**Modification to run CPU09CMI on 5MHz bus.**  
**There may be timing errors in this experimental version, read FLP\_MRDY.**

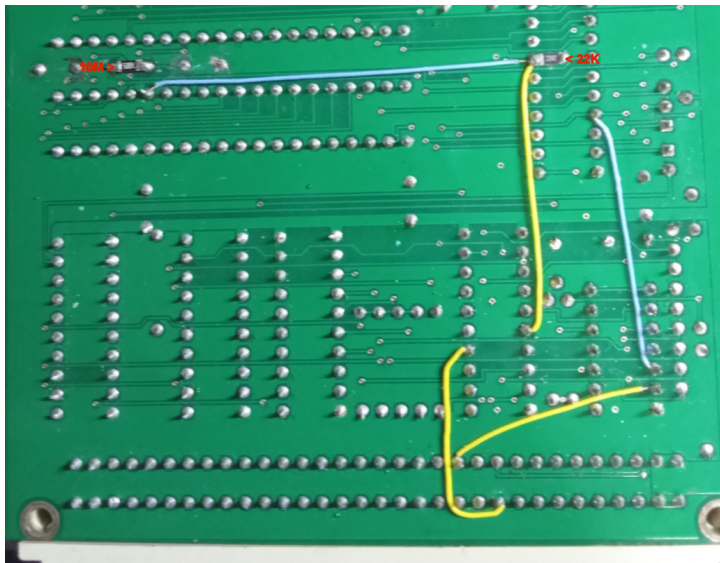
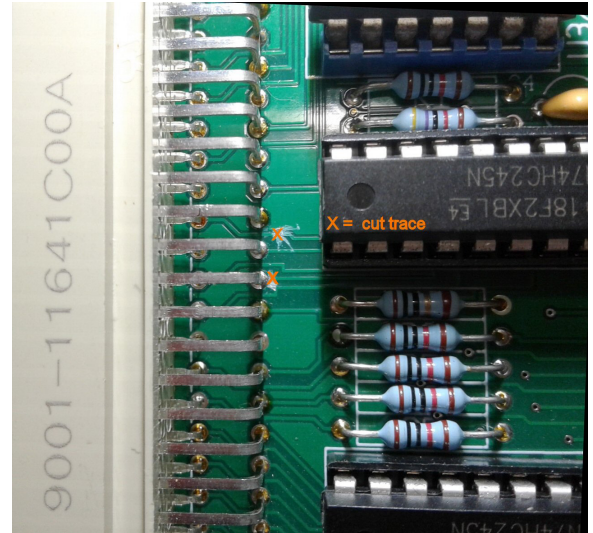
Replace xtal into 20MHz.  
Replace C1 and C2 by 15pF.  
Place 10M smd between crystal pins.  
Replace GAL CMI\_1 by CMI-4\_1  
Only use the HD63C09.

Cut trace between U4-14 and J1 C-21 (B\_VMA-)  
For REV:0.9 print only cut trace from J1 A23 to R15

Cut trace between U13-19 and via (OVMA-)  
Place 22K resistor between U13-19 and Gnd  
Place wire from U6-35 to U13-19 (blue) and U4-6 (Q) (yellow)  
Place wire from U4-14 to J1 A-23 (B\_Q) (yellow)

Place wire from U3-7 to J1 C-21 (B\_VMA-), Or:  
**To keep CPU09CMI 68x02 compatible  
or need VMA- signal with 68x02 on the bus  
for CPU09GPP or CPU09RAM card.**

Cut trace between U3-4 and U3-5

Place wire from U3-5 to U13-9 (VMA) (blue)  
Place wire from U3-6 to J1 C-21 (B\_VMA-) (yellow)
